Storm Water Facility Inspection/Site Visit Report Form

Job Address 1820 S RESERVOIR

Stormwater Inspection 1820 S Reservoir St Pomona, California

PHOTOGRAPH 3.

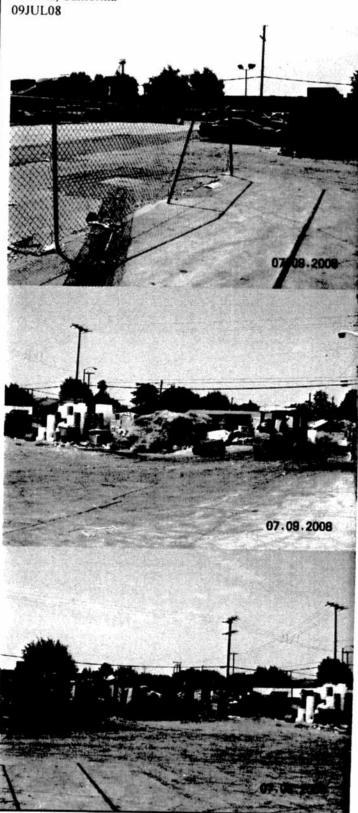
The tenant was instructed to cover the storage piles and to increase sweeping frequency.
